UNITED STATES PATENT AND TRADEMARK OFFICE

10/566,814

Office Action Summary	Application No. 10/566,814	Applicant(s) JUDIN ET AL.	
	Examiner TIMA M. MCGUTHRY-BANKS	Art Unit 1793

DETAILED ACTION

FIG. 3

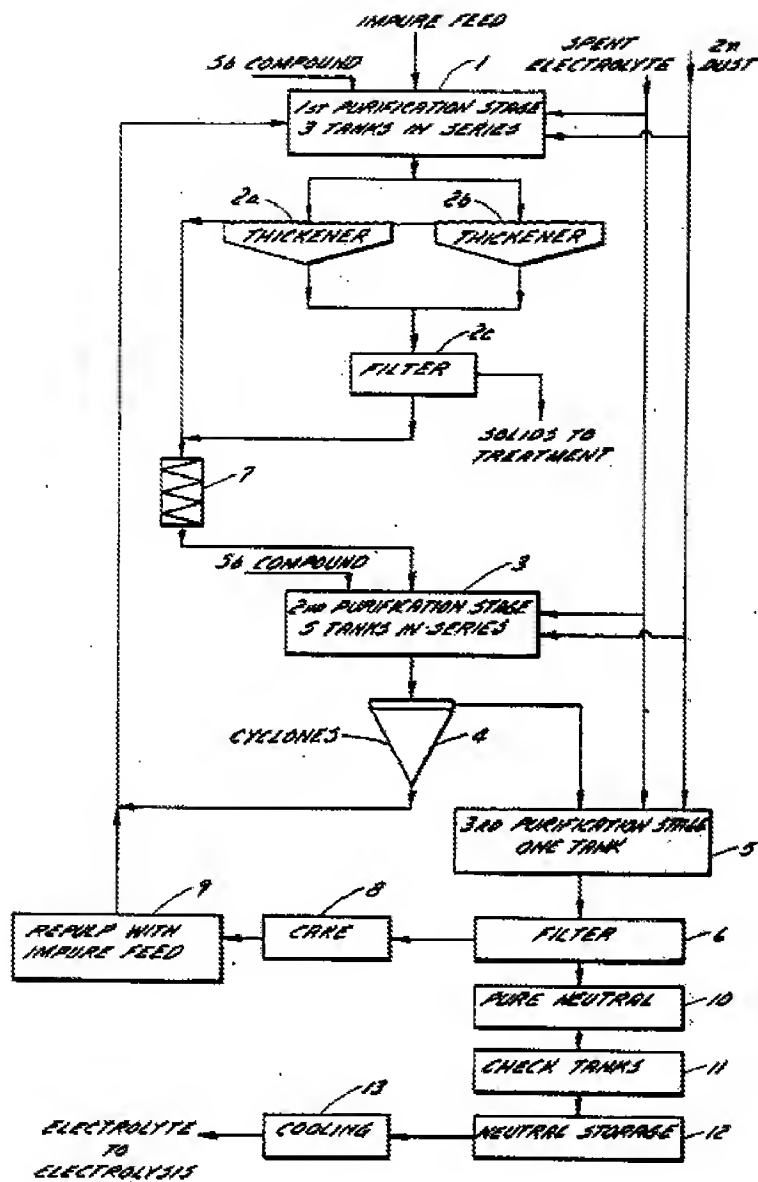
Ghatas anticipates the claimed invention. Ghatas teaches purifying zinc sulfate solutions as shown below in FIG. 3

The metal separation reactors are read by 1, 2a, 2b, 2c and 3. The feeding device is read by shown by the line "IMPURE FEED." The junction line is shown by the line between 3 and 4, the classification device is shown by cyclones 4, the pipe extending from the metal separation reactor is shown by the line between 3 and 4, recycling means is shown by the line from 4 and 9 to 1 and means for removing the worse substance is shown by the line to 5. Regarding Claim 14,

the cyclone is placed substantially in conjunction with the metal separation reactor. Regarding Claims 15 and 16, 4 is a cyclone. Regarding Claims 17-18, language in the claim that suggests or makes optional but does not require steps to be performed or does not limit a claim to a particular structure does not limit the scope of a claim or claim limitation, for example statements of intended use or field of use. See MPEP § 2106.
